Request for Proposals
for the Building Demolition Services
for the Town of New Sharon
New Sharon, Maine

Letter of Clarification
February 24, 2020

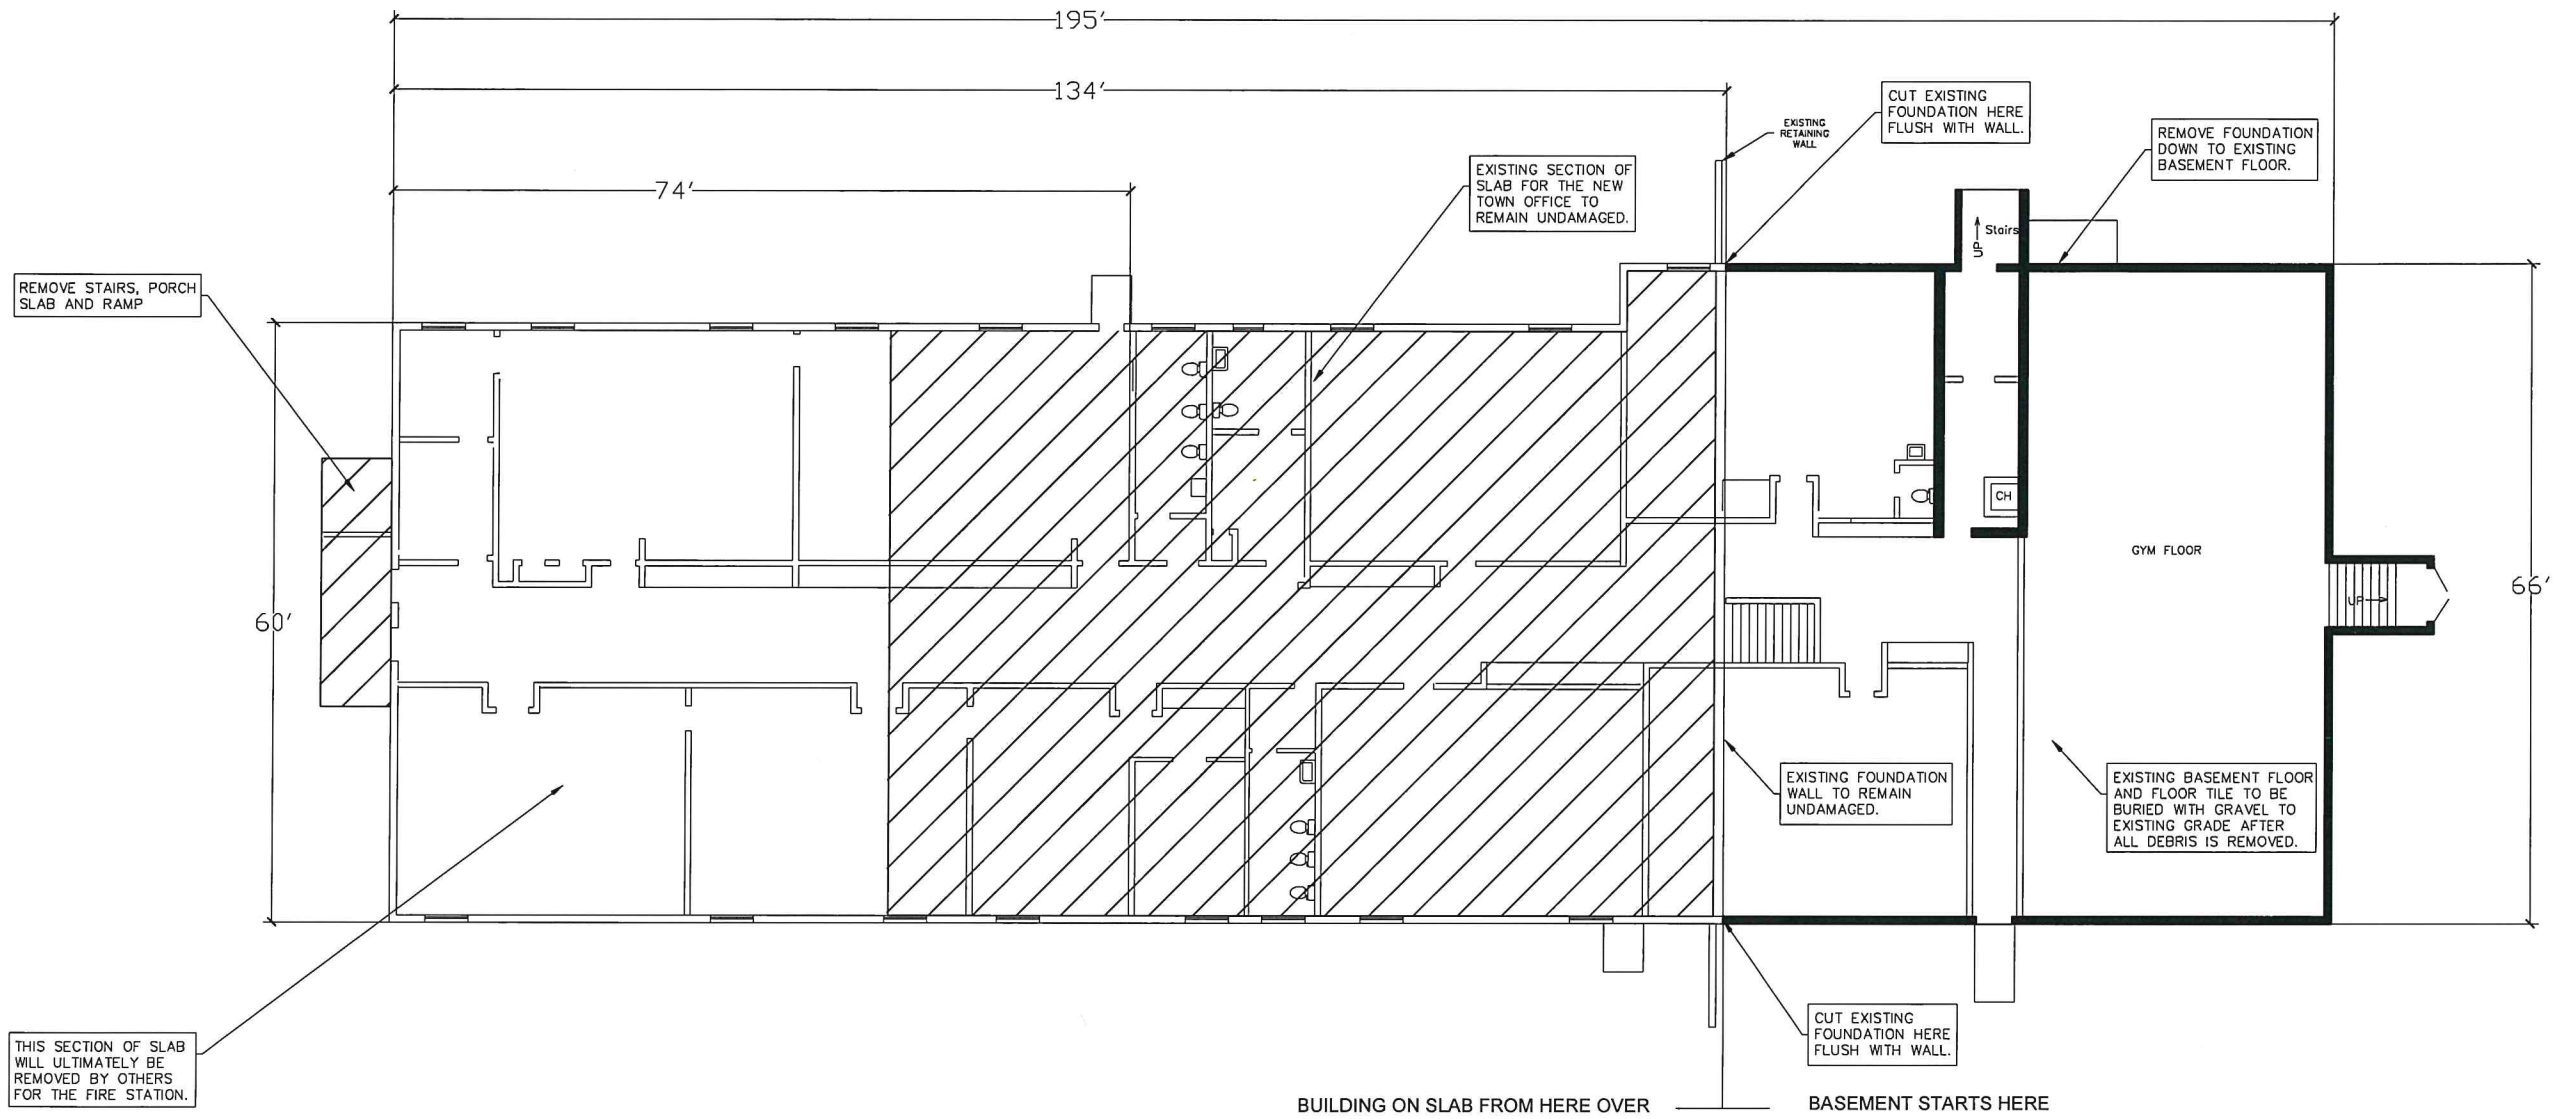
1. As shown on the Revised Plan, a portion of the slab needed to remain intact as it will be used for the floor of the new Town Office. The original plan called for approximately 60 x 60 section of slab to remain intact. The new amount to remain intact shall be 60 x 84.

EXISTING SECTION OF SLAB FOR THE NEW TOWN OFFICE TO REMAIN UNDAMAGED.
